| <b>Detailed Site Plan</b>                           | <b>DSP-15031-01</b> |

| Application   | General Data                 |                 |
|---|------------------------------|-----------------|
| <b>Project Name:</b><br>EZ Storage College Park<br><br><b>Location:</b><br>On the south side of Branchville Road, approximately 1,080 feet east of its intersection with Rhode Island Avenue.<br><br><b>Applicant/Address:</b><br>Siena Corporation<br>8221 Snowden River Parkway<br>Columbia, MD 21045 | Planning Board Hearing Date: | 05/23/19        |

STAFF REPORT

SUBJECT: Detailed Site Plan DSP-15031-01  
Departure from Design Standards DDS-648  
Departure from Parking and Loading Standards DPLS-459  
Type 2 Tree Conservation Plan TCP2-020-2016-01  
EZ Storage, College Park

# LANDSCAPE PLAN

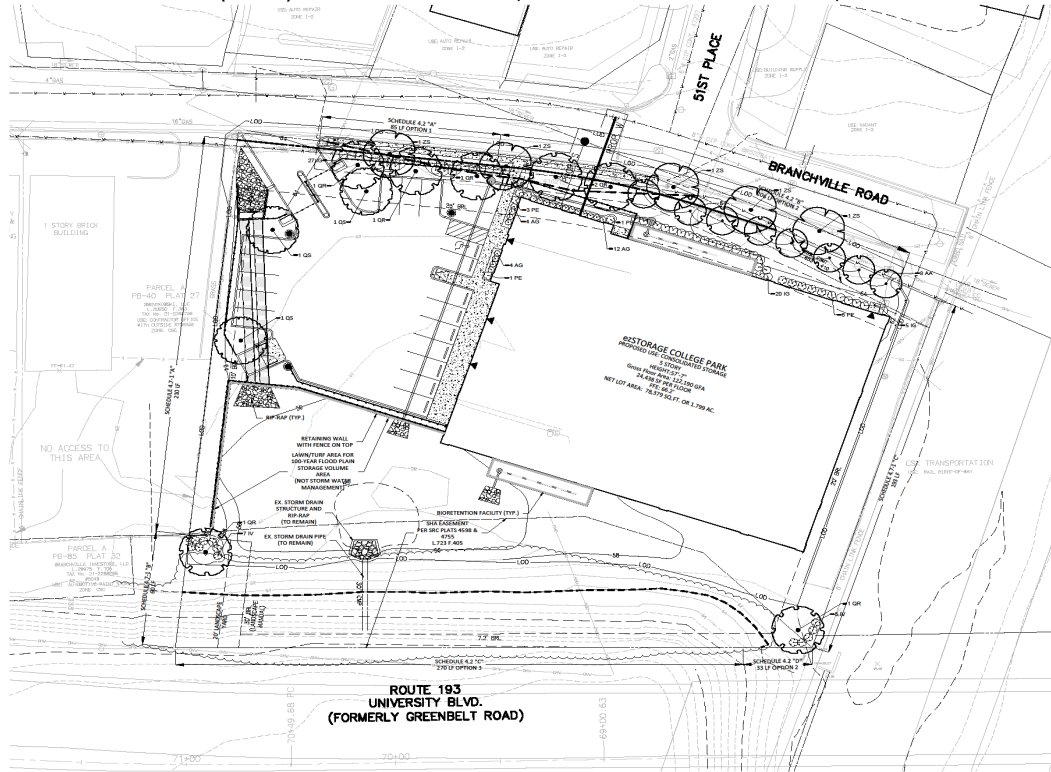
- f. Correct the proposed green area in the Zoning Summary and Site Data chart to reflect the proposed and existing conditions.
- g. Relabel the landscape plan to “Landscape and Lighting Plan.”

- h. Provide plant quantities on the tables to reflect what is presented on the plan.
- i. The Type 2 tree conservation plan (TCP2) shall be revised, as follows:

# TREE CONSERVATION PLAN

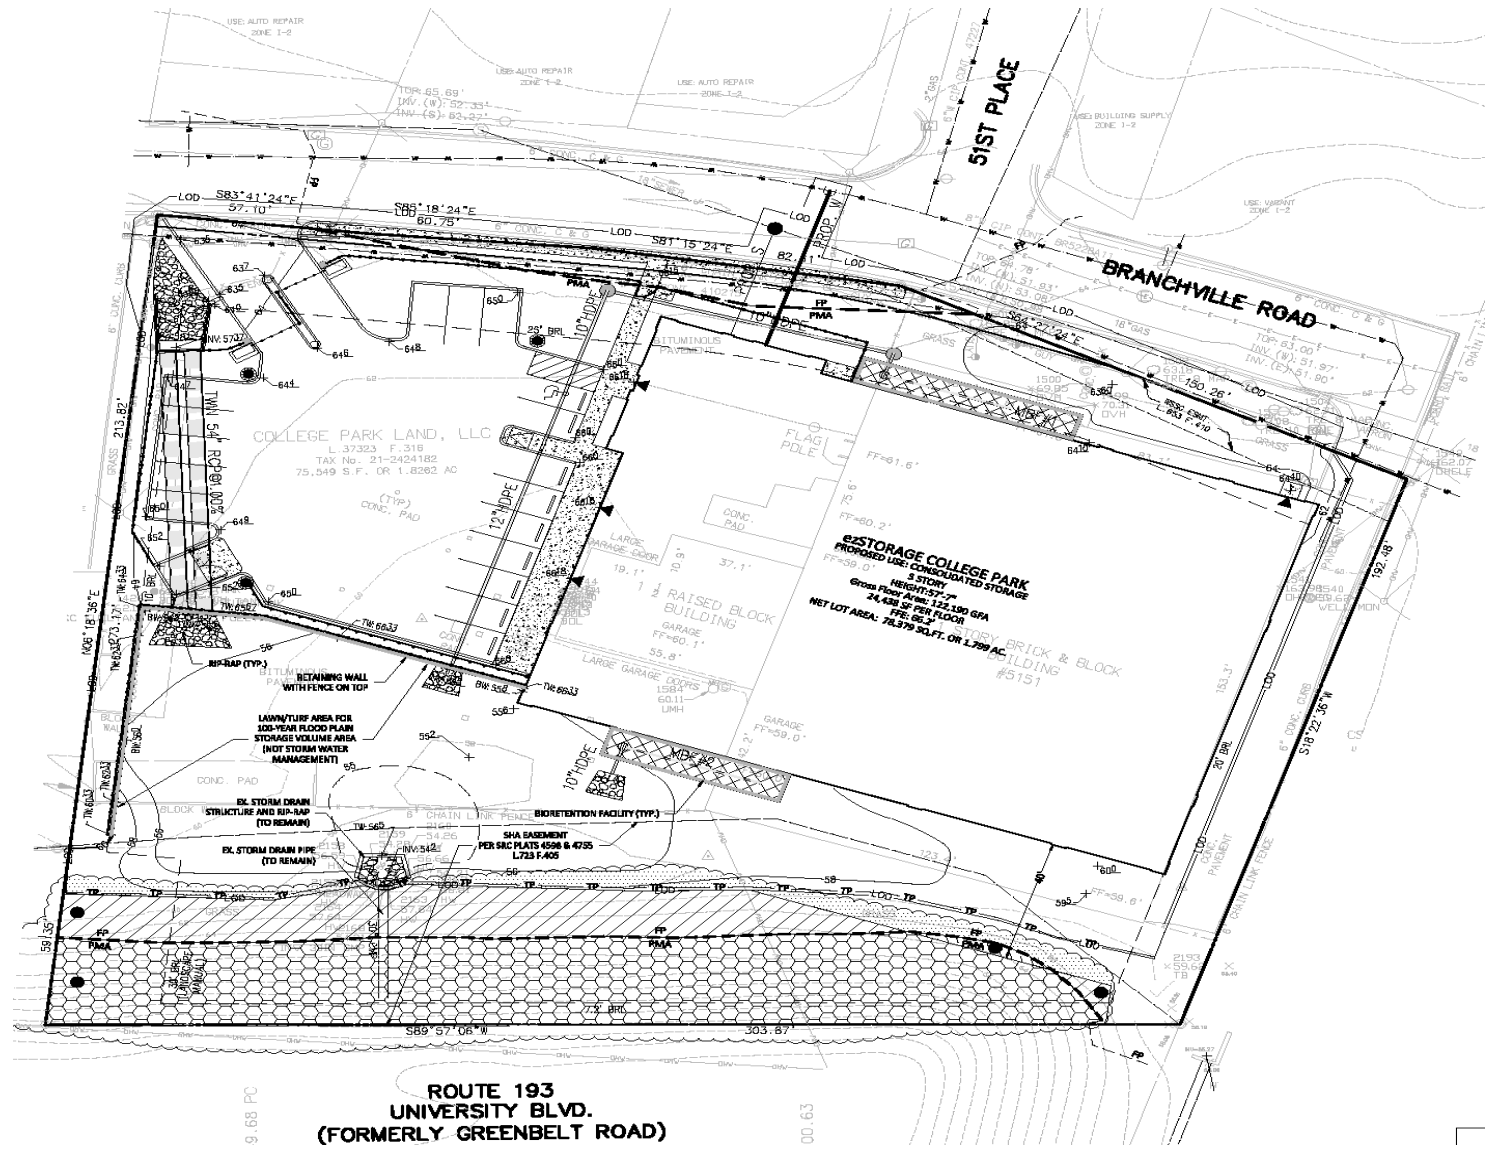
- (1) Revise the TCP2 notes by completing the Invasive Plant Removal notes and providing an invasive species management plan.
  - (2) Label all structures as either existing or proposed.

- (3) Label the proposed retaining wall.
  - (4) Revise the location of all temporary tree protection fencing shown to be placed approximately two feet outside of the limits of disturbance.

- (5) Add a north arrow on the plan.
  - (6) Identify and label all existing and proposed stormdrain easements. Label all woodlands within existing stormdrain easements to remain on-site as “woodland retained-assumed cleared” and all woodlands within proposed stormdrain easements as cleared using the appropriate symbol per the Environmental Technical Manual on the TCP2 plan and legend.

- (7) Show all areas within 40 feet of the front and rear of the proposed building as cleared, and expand the limits of disturbance accordingly on the TCP2 and all relevant sets of plans associated with this DSP application.

- (8) In the TCP2 legend re-label “Woodland Retained Assumed Cleared (WP-NC)” to “Woodland Retained Assumed Cleared (WP-AC),” as labeled on the plan.

- (9) Revise the TCP worksheet to reflect the same area of net tract woodland retained, not part of requirements, as shown on the plan.

- (10) Complete the revision box on the TCP2.
- (11) After all revisions and corrections have been made, the plan shall be signed and dated by the qualified professional who prepared it.
